Subject: Class 1* Permit Modification Notification Requiring Prior Agency Approval, Waste Isolation Pilot Plant Hazardous Waste Facility Permit Number: NM4890139088-TSDF

Class 1* Permit Modification Notification

Addition of Four New Shielded Containers

**Waste Isolation Pilot Plant
Carlsbad, New Mexico**

New SC-55G2 Shielded Container and Container Assembly

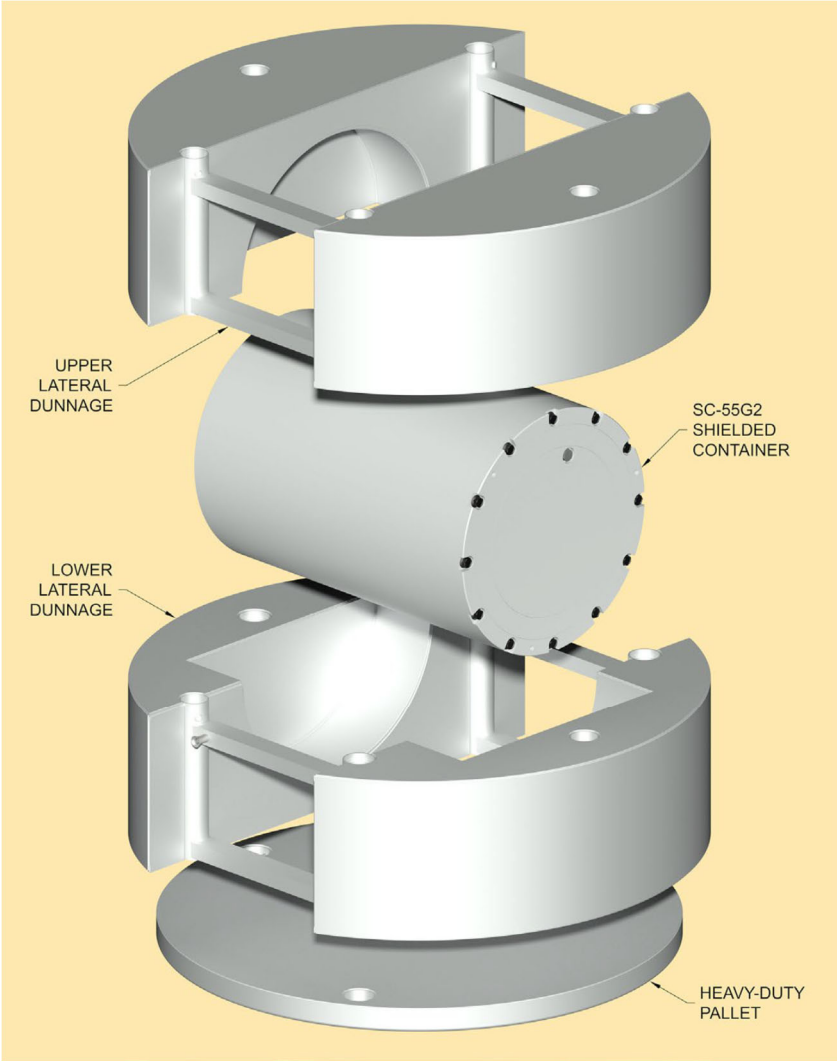
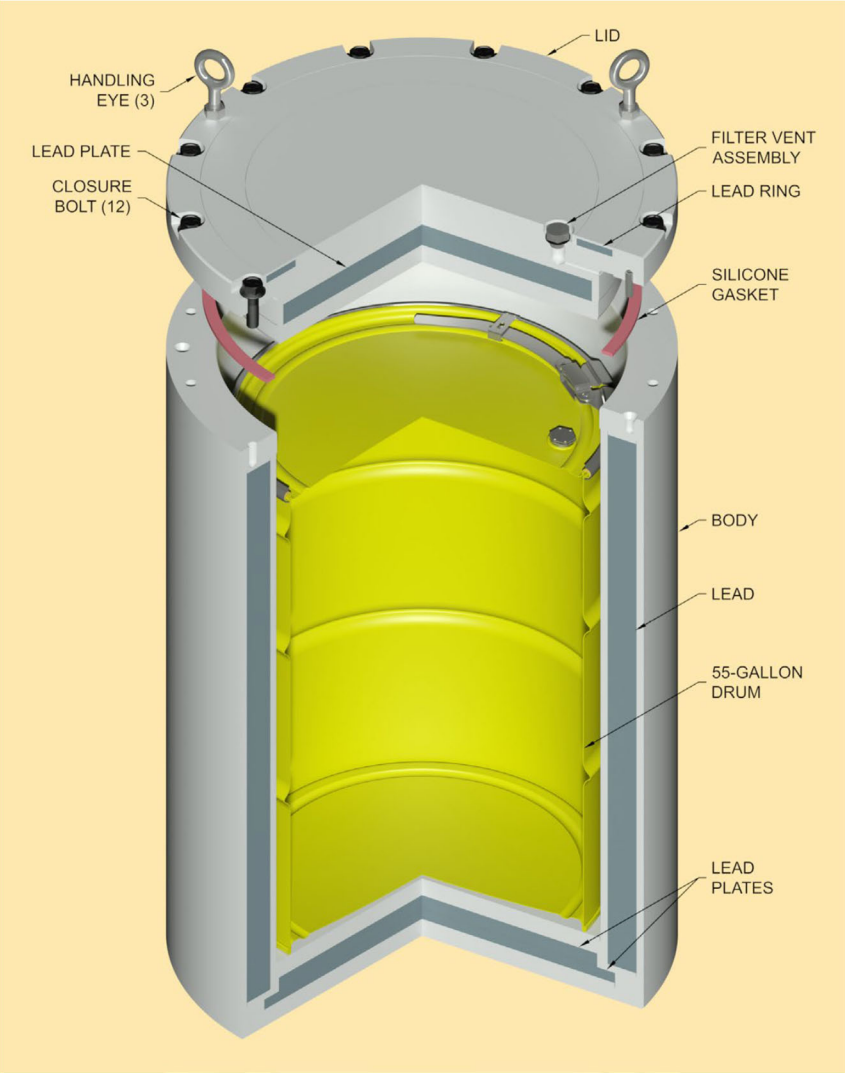
- SC-55G2 Shielded Container
 - The SC-55G2 shielded container has an overall diameter of approximately 31-in. and an overall height of approximately 45.75-in. The SC-55G2 nominally has 2-in. (1.98-in. minimum) of lead shielding between 0.50-in. thick inner and outer shells. The shells connect to an upper flange and a 4.25-in. thick steel base. The base integrates a 27-in. diameter, 0.75-in. thick lower lead plate, and a 24.5-in. diameter, 1.00-in. thick upper lead plate. The 5.76-in. thick steel lid integrates a 23.75-in. diameter, 1.50-in. thick lead plate. The lid also integrates a 26.625-in. outside diameter, 21.625-in. inside diameter, 0.50-in. thick lead ring. The lid is bolted to the container. A gasket of silicone rubber is utilized for lid closure. The empty weight of the SC-55G2 is approximately 5,900 pounds. The SC-55G2 accommodates a 55-gallon steel drum, which will contain RH TRU mixed waste. The SC-55G2 is configured as a lateral single unit on a circular pallet surrounded and supported by upper and lower lateral dunnage components and will be transported as one single unit within the HalfPACT package.
